REGION SOUTHERN
SUB. LEITHTON 332
CN
SIGNALS AND COMMUNICATIONS HOMEWOOD
DES.
CHL
SITUATION SKETCH
SCALE 1" = 20'
AURORA, IL
MONTGOMERY RD
LEI-018.19-0

REGION SOUTHERN
SUB. LEITHTON 332
CN
SIGNALS AND COMMUNICATIONS HOMEWOOD
DES.
CHL
SITUATION SKETCH
SCALE 1" = 20'
AURORA, IL
87TH ST
LEI-017.68-0

DENOTES PROPOSAL 15-0124
REVISION 10/04/15

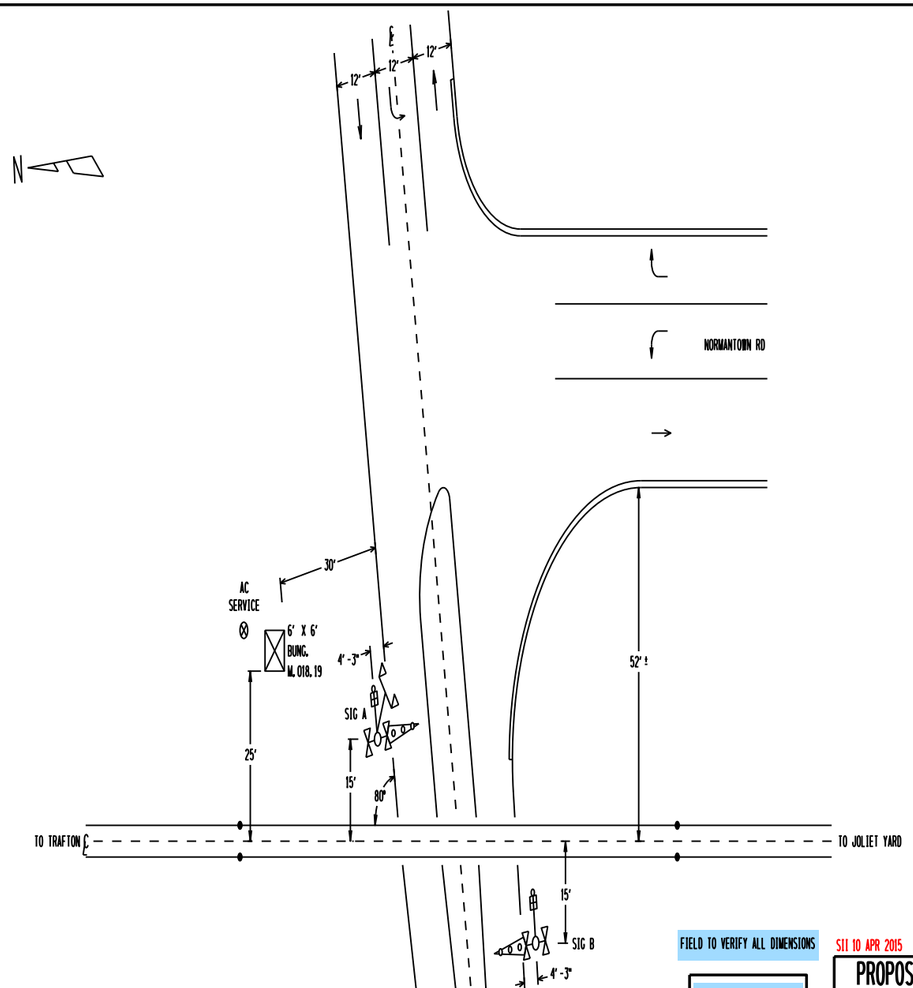
PROPOSED
DESIGN NO. 15-0124
RED-IN YELLOW-OUT

PROPOSED D	M	T	REVISIONS	D	C	COMPLETED D	M	T	C
			PLAN REDRAWN			15	12	14	KLT
10	04	15	ADD INTERCONNECT	DAB	DRD

INDEX, TRACK LAYOUT, R & A, & PTC CHART
AURORA, IL
87TH ST

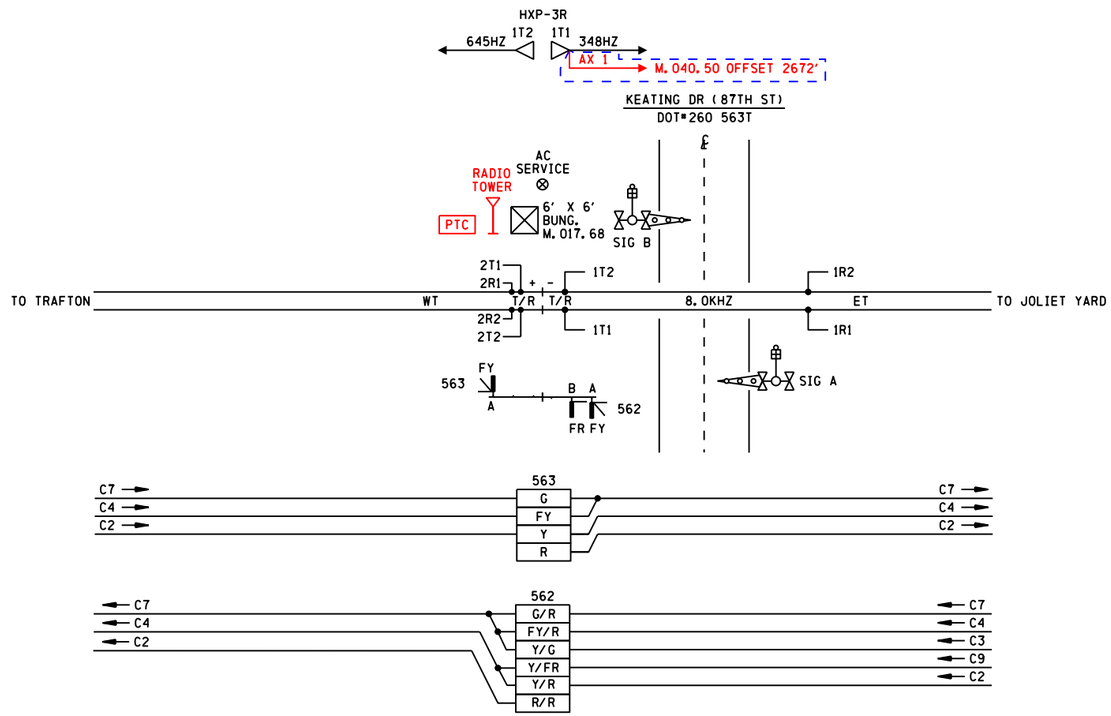
PROPOSED D	PROPOSED M	PROPOSED Y	REVISIONS	D	C	COMPLETED D	COMPLETED M	COMPLETED Y	C
			PLAN REDRAWN			15	12	14	KLT
15	12	14	PTC UPGRADE	DJB	SIA				
10	04	15	M.018.19 INTERCONNECT	NAD	MRB

HXP WIRING

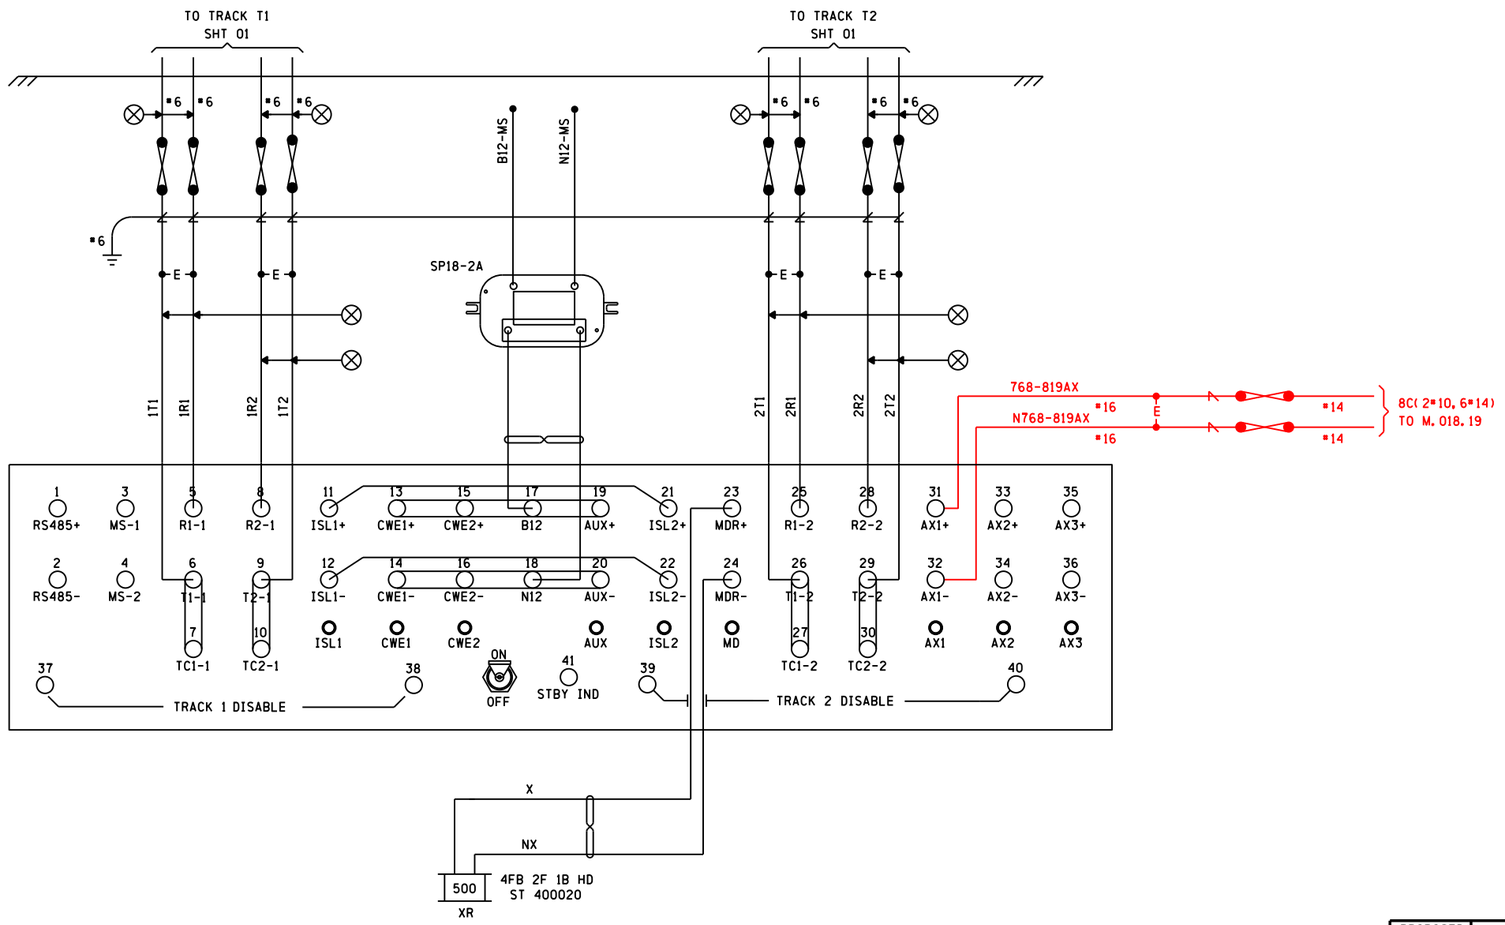
PROPOSED D	PROPOSED M	PROPOSED Y	REVISIONS	D	C	COMPLETED D	COMPLETED M	COMPLETED Y	C
			PLAN REDRAWN			15	12	14	DJB
10	04	15	M. 018. 19 INTERCONNECT	NAD	MRB

SIGNALS AND COMMUNICATIONS HOMEWOOD
DES. BJH
02 DECEMBER 2001
CH. JJ
SIDE 'B' TERMINAL BOARD DETAIL
AURORA, IL
87TH ST
LEI-017.68-11
DOT#260 563T

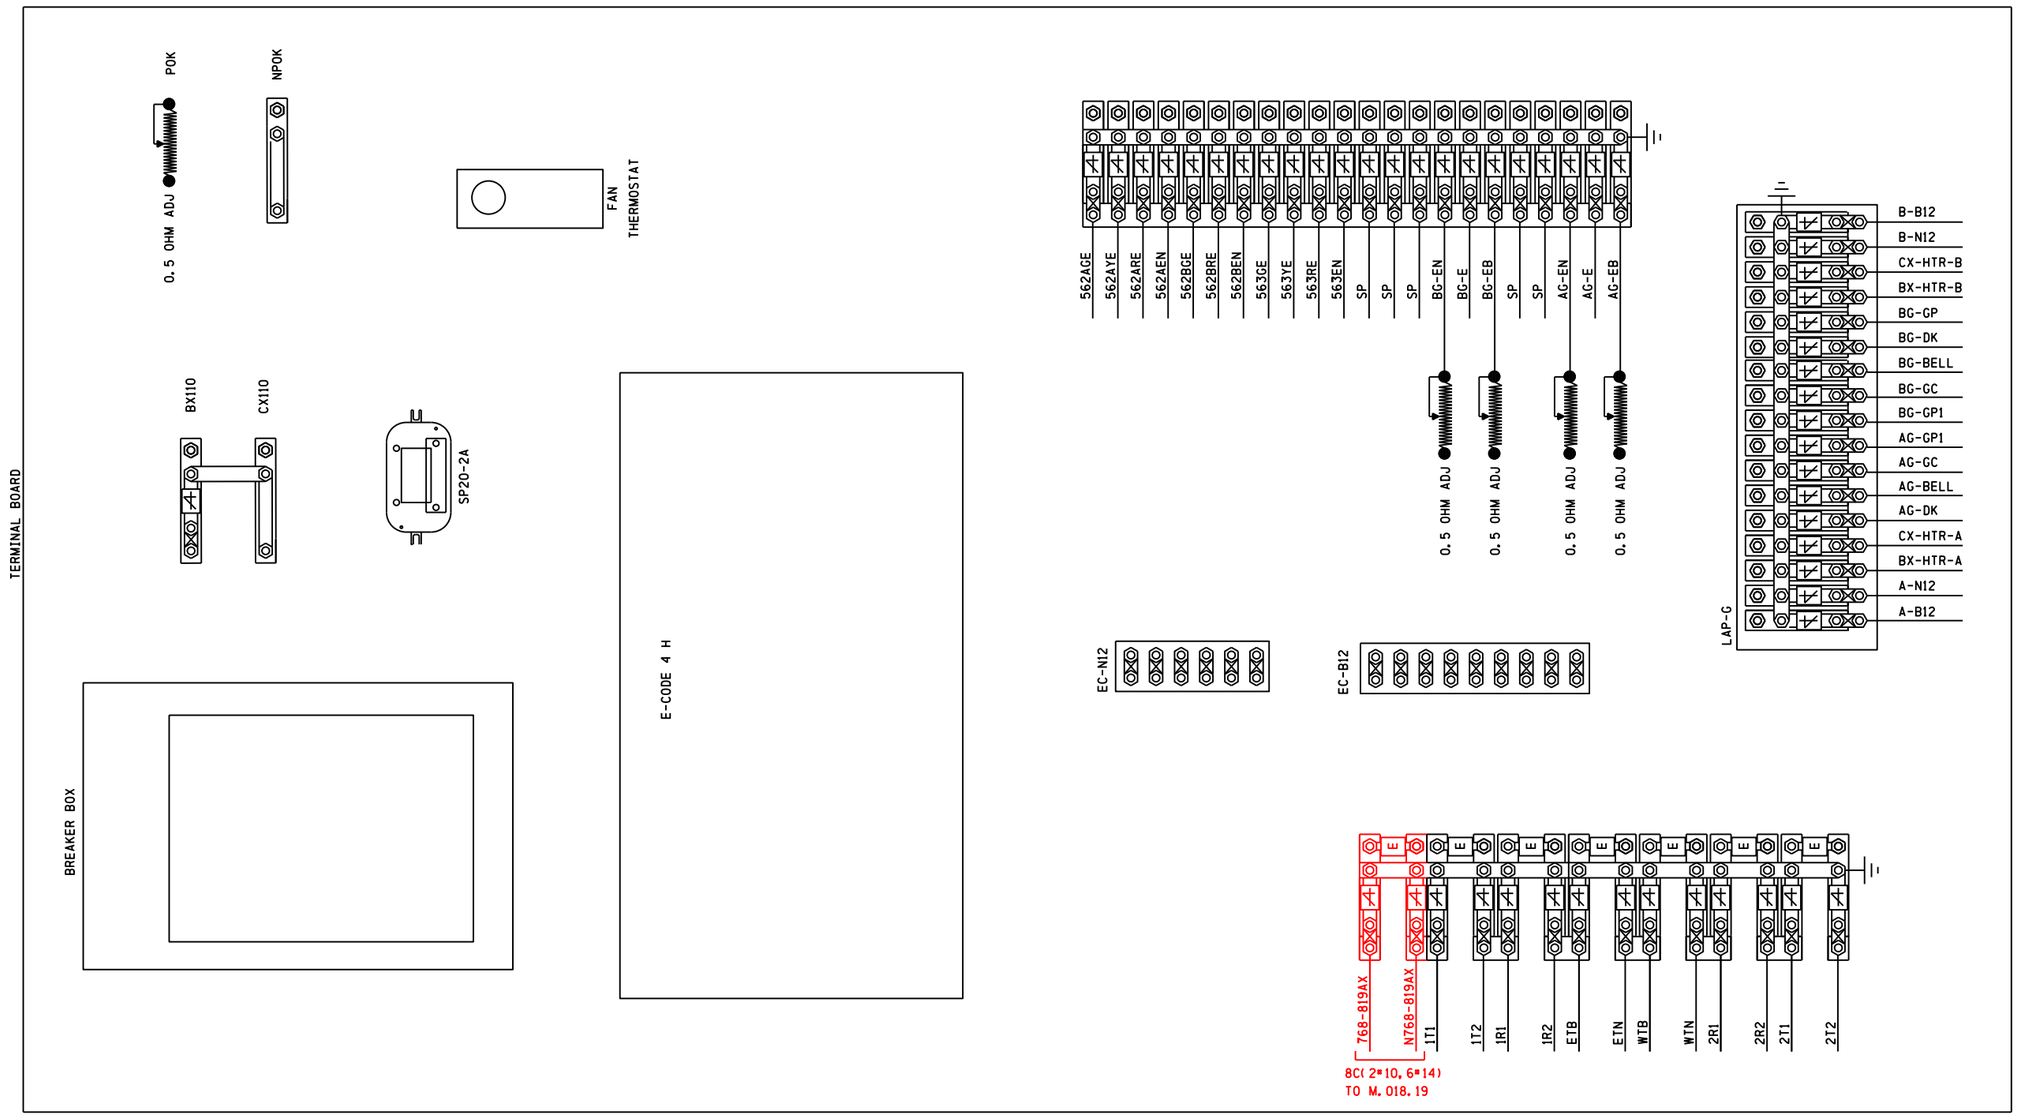
PROPOSED D	PROPOSED M	PROPOSED Y	REVISIONS	D	C	COMPLETED D	COMPLETED M	COMPLETED Y	C
			PLAN REDRAWN			15	12	14	DJB
10	04	15	M.018.19 INTERCONNECT	NAD	MRB
